## Detailed Site Plan

### 1020 Largo Center Drive Sunoco

## DSP-23017

SUBJECT: Detailed Site Plan DSP-23017  
1020 Largo Center Drive - Sunoco

**Figure 1: Detailed Site Plan**

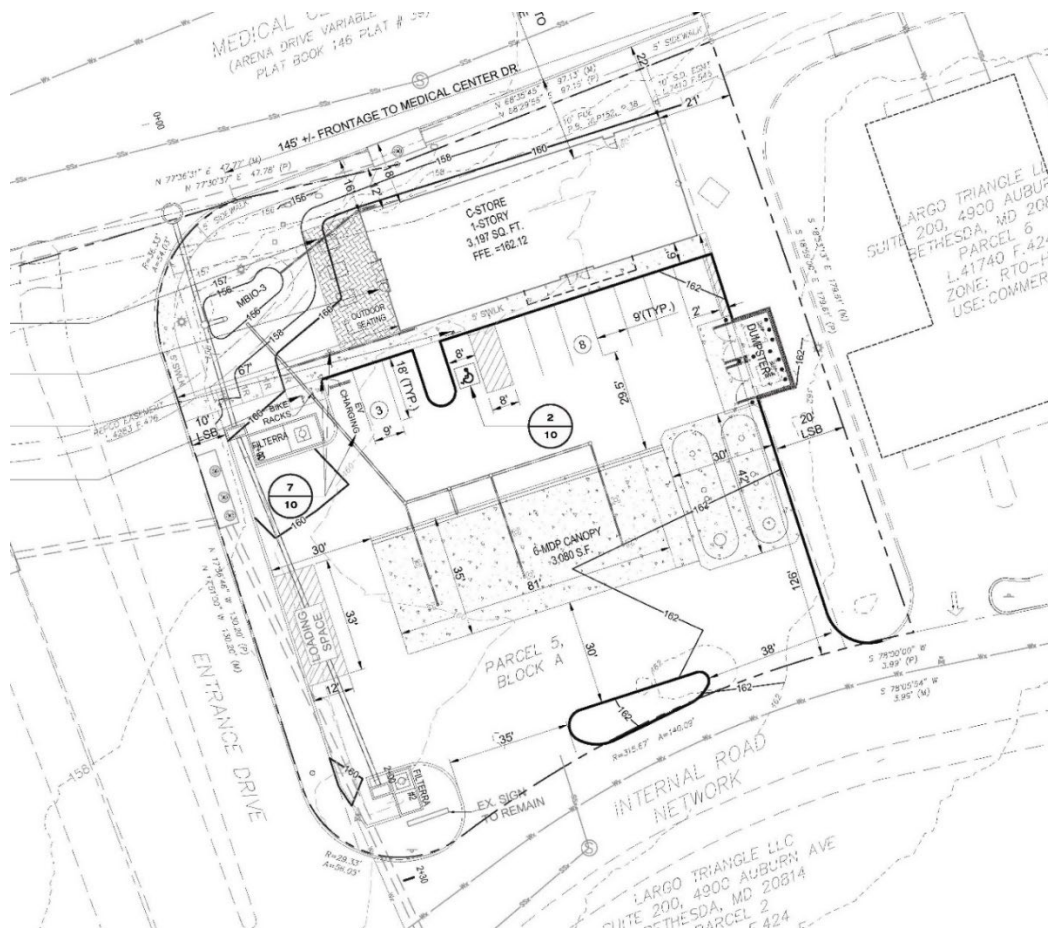
The site plan also depicts an outdoor seating area adjacent to the food and beverage store building. This outdoor seating area will be screened from the surrounding roadways via landscaping, to create an enclosed area. The outdoor seating area may be accessed directly through the food and beverage store or the proposed 5-foot-wide sidewalk in front of the building. This outdoor seating area will be constructed with decorative brick pavers and include tables for patrons to consume their food outside.

- e. Provide a maximum 48-inch-high decorative fence to provide an enclosure for the proposed outdoor seating area, subject to approval of Urban Design Section of the Development Review Division of the Prince George's County Planning Department.
- f. Demonstrate conformance to Condition 5 in Comprehensive Design Plan CDP-8905 and note on the plans the provided green space.

**Figure 2: North Elevation Along Medical Center Drive (Top) and South Elevation (Bottom)**

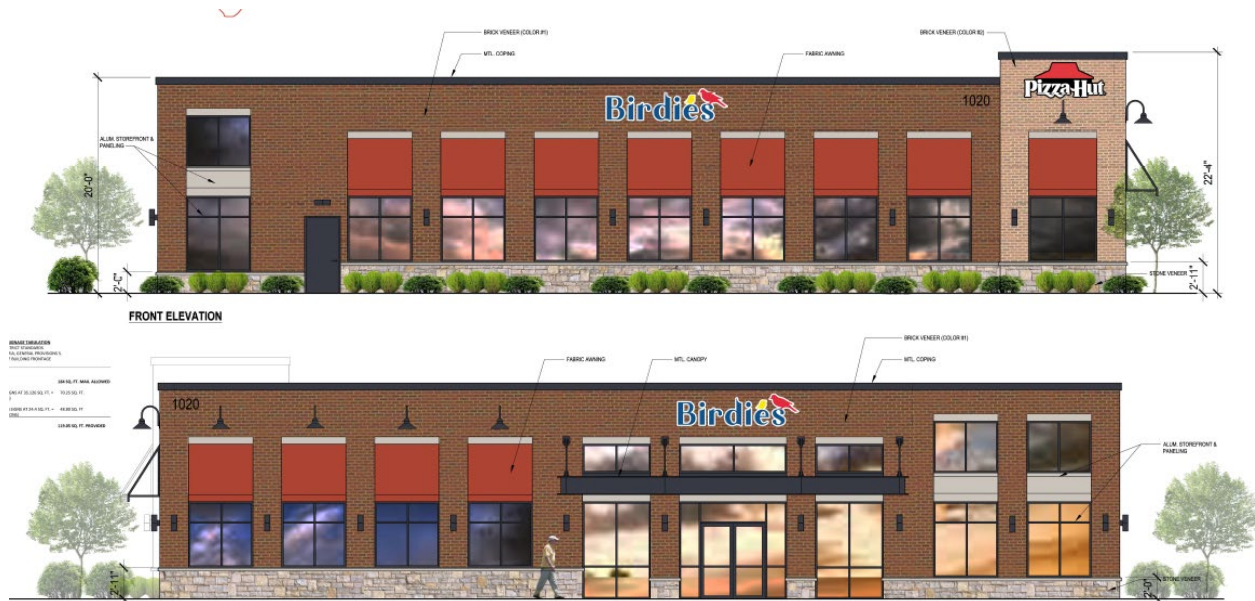
The architectural design of the proposed building is contemporary with a flat roof. The building is finished with a mix of materials, including brick veneer as the primary building material. The proposed food and beverage store has three sections, a base constructed of stone veneer, a brick veneer middle portion, and a flat roof delineated by black metal coping. The brick material, proposed in two shades, is consistent with the existing shopping center and encouraged by the development district standards. The food and beverage store building also features a corner tower element on the front elevation, facing Medical Center Drive. This tower element will include light-red brick veneer to distinguish it from the remainder of the building. The tower will also project approximately 2 feet above the roofline to create variations throughout the building. All elevations will feature aluminum windows with glazing, and red awnings will be provided above most windows. A condition

is included herein requiring the applicant to label building elevations based on the cardinal directions.

- b. Revise the architectural requirements, as follows:
  - (1) Label building elevations based on the cardinal directions.
  - (2) Add the dimensions of the building and the outdoor eating area.

**Figure 3: Gas Canopy Signage on the East and West Elevations**

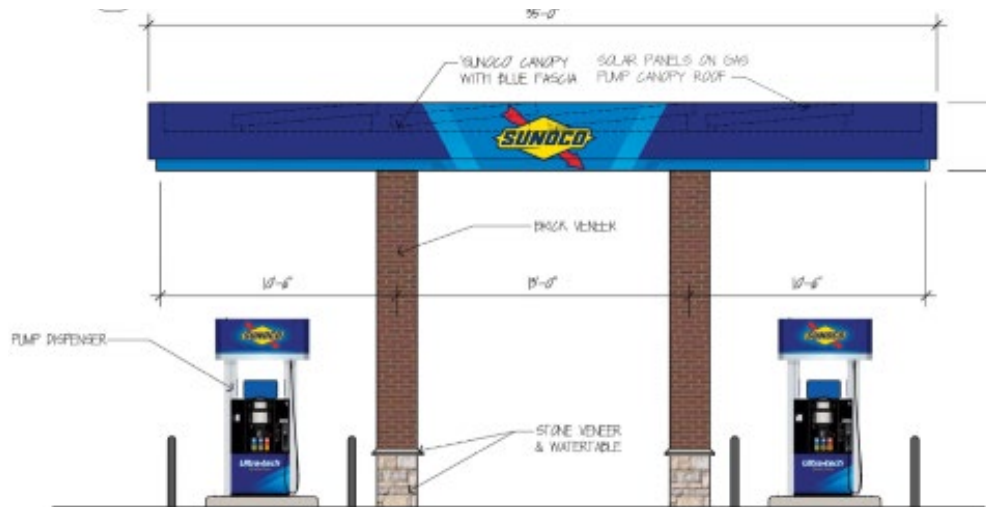
The subject DSP includes four building mounted signs for the proposed food and beverage store building. One is located on the north and west elevations, respectively, and two are on the north elevation. The submitted plans also include three signs for the gas station canopy. Signs included with this DSP are in conformance with the development district standards. Conditions are included herein requiring the applicant to provide large-scale drawings of these spaces with details, dimensions, and illumination, and add the signage schedule for the proposed building mounted signs to the coversheet. At the southwest corner of the subject site, there is an existing freestanding sign that will remain and be updated with new information. Per page 130 of the sector plan, "refacing of an existing sign with no increase in sign area or increase in the height of freestanding signs is exempt from the development district standards." A condition is included herein requiring the applicant to add the signage schedule for the freestanding sign to the coversheet and note that this sign is exempt from the development district standards, in accordance with page 130 of the sector plan.

- (3) Add the height of the building and canopy to each structure.
- c. Revise the signage requirements, as follows:
  - (1) Include large-scale drawings of these spaces with details, dimensions, and illumination.
